Outdoor Power Equipment Institute (Greg Knott)

RE: California Air Resources Board 2026 State Implementation Plan Revisions for the California Extreme Ozone Nonattainment Areas

In September 2020 CARB published the *2020 Emissions Model for Small Off-Road Engines – SORE2020* (SORE2020). OPEI has repeatedly highlighted that SORE2020's reliance on inaccurate, telephone-based survey data results in overestimates of the

Figure 1 – Residential walk-behind mowers runtime per use (minutes) variability based on CARB telephone surveys (2012 & 2018) and in-use data collection (2001). 2006 commercial landscaper minutes/use accumulated from 2006 in-use data is also included for additional reference purposes.

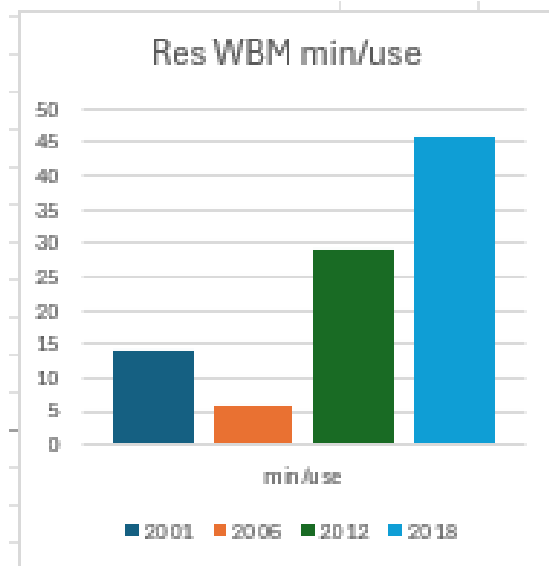
Residential walk-behind mowers (RWBM) are a good example of CARB survey-to-survey data discrepancies. Estimated RWBM minutes per use increased from 29.2 minutes/use and 15.5 hours/year (CARB's 2012 survey (n=2999)) to 45.6 minutes/use and 19 hours/year (2018 survey (n=1152)) (see Figure 1 below). This annual runtime increase, approximately 4 hours/year, corresponds to an approximate 25 percent increase in emissions per unit per year. Similarly, the 2012 to 2018 survey data suggested an increase in residential chain saw runtime from 39.2 minutes/use and 7.9 hours/year to a whopping 108 minutes/use and 18 hours/year. This is an annual runtime and emissions increase of more than 100% from survey to survey. Recognizing California has the 49th smallest average residential parcel size in the U.S., data suggesting the average RWBM runs more than 45 minutes per use, or that the average residential chain saw runs 18 hours per year is highly questionable.

There are several potential reasons for such deviations. Based on OPEI’s in-depth survey data review it is unlikely most SORE-equipment users accurately track equipment runtime and often underestimate SORE-powered equipment’s efficiency, in effect crediting themselves for much more work than is performed. Compounding telephone survey response issues include: small sample sizes for some equipment types and use categories (for example, CARB updated residential wood splitter annual use from 1 hour/year to 48 hours/year, a factor of 48x, based on a single survey response and updated residential lawn tractor annual use from 29 hours/year to 83 hours/year based on just 13 gas-powered units); lack of any/appropriate data correction (for example, residential “lawn and garden” equipment responses should be corrected for the respondents property size versus the state average); rounding errors based on survey “telescoping” (for example, respondents often rounded minutes to the next hour or years to the next 5th or 10th year); and exaggerated, dishonest or misinterpreted responses (for example, responses of residential chain saws *running* for 24 hours at a time, residential lawn tractors *running* 7 days a week for 2.5, and landscapers *running* equipment for dozens of man-hours longer than the typical 40-50 hour work week). Some of these potential flaws were highlighted in CSU-F’s survey report. CSU-F specifically cautioned: “(T)he reader should not take for granted that unweighted results accurately reflect the (average of data),” and “(T)ake into account that (estimates) based on small sample sizes have large confidence intervals and may be less accurate than desired.... Smaller estimates for particular types of equipment many not be
